Model: PE-P1E	Date: 07-Apr-09	No.: RM035001c
---------------	-----------------	----------------

Subject: Firmware History - Engine		Prepared by: H.K.	
From: 2nd Overseas Tech Support Sec., 2nd PQM Dept.			
Classification:	<input type="checkbox"/> Troubleshooting	<input type="checkbox"/> Part information	<input type="checkbox"/> Action required
	<input type="checkbox"/> Mechanical	<input type="checkbox"/> Electrical	<input type="checkbox"/> Service manual revision
	<input type="checkbox"/> Paper path	<input type="checkbox"/> Transmit/receive	<input type="checkbox"/> Retrofit information
	<input type="checkbox"/> Product Safety	<input checked="" type="checkbox"/> Other (Firmware History)	<input checked="" type="checkbox"/> Tier 2

Model: PE-P1E		Date: 19-Dec-13	No.: RM035011
Subject: Shaft: Paper Feed Roller		Prepared by: H.K.	
From: 3rd Tech Service Sect., MFP/P Tech Service Dept.			
Classification:	<input type="checkbox"/> Troubleshooting	<input checked="" type="checkbox"/> Part information	<input type="checkbox"/> Action required
	<input type="checkbox"/> Mechanical	<input type="checkbox"/> Electrical	<input type="checkbox"/> Service manual revision
	<input type="checkbox"/> Pape

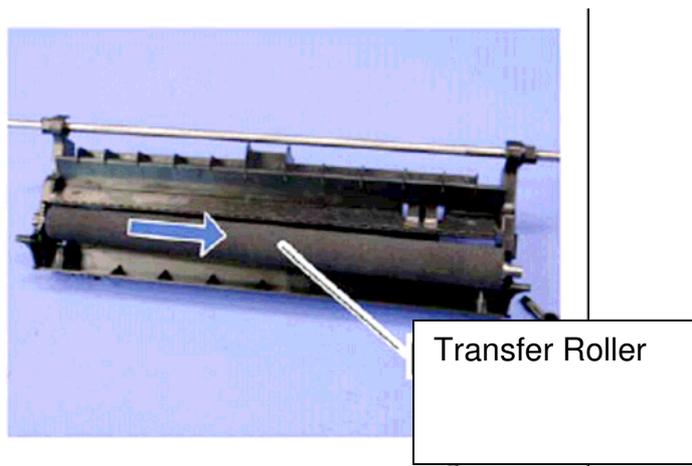
Change: This part was newly registered as a service part.

Reason: As per a request from the field.

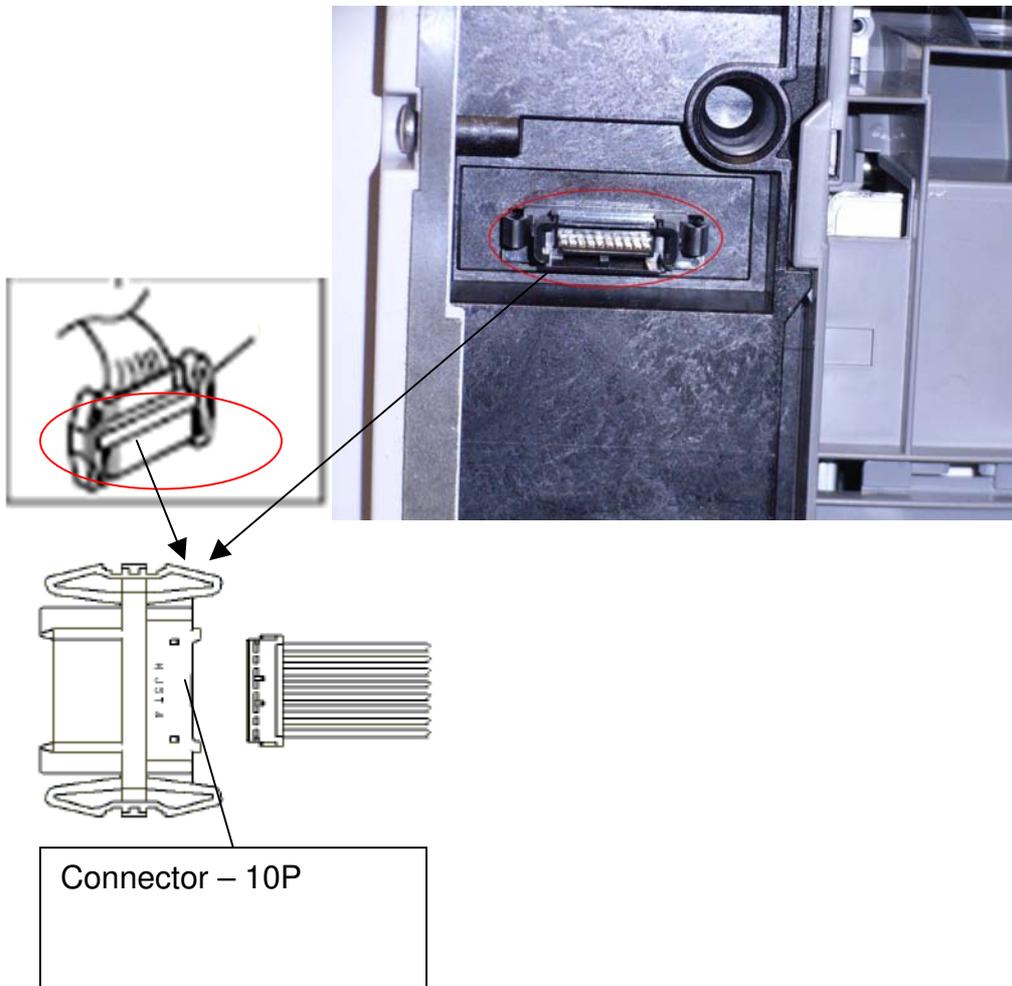
Change/Reason: This part was missing from the parts catalogue.

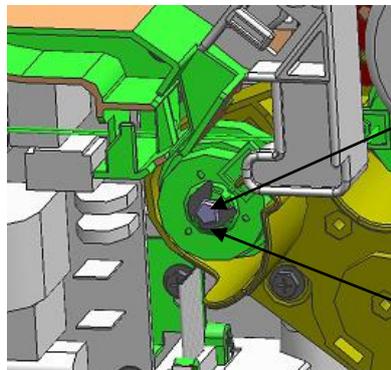
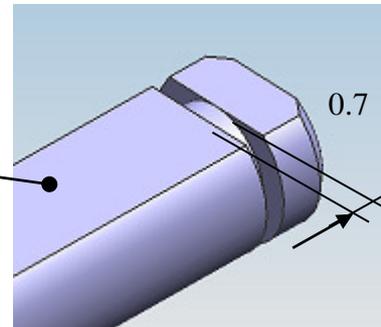
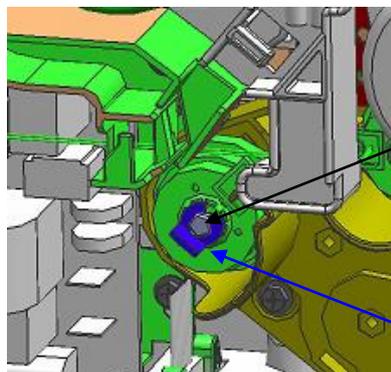
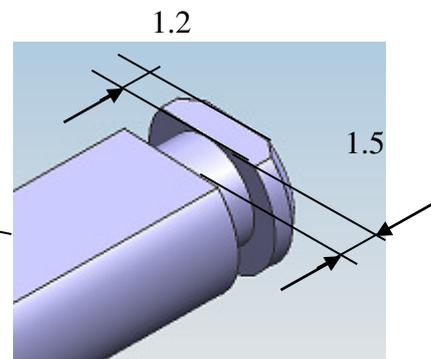
Change:

- 1) The width of the e-ring groove in the paper feed roller shaft was increased.
- 2) The e-ring was changed to a C-ring.

Reason: To facilitate assembly.

08050089 → H5213355 New index
27
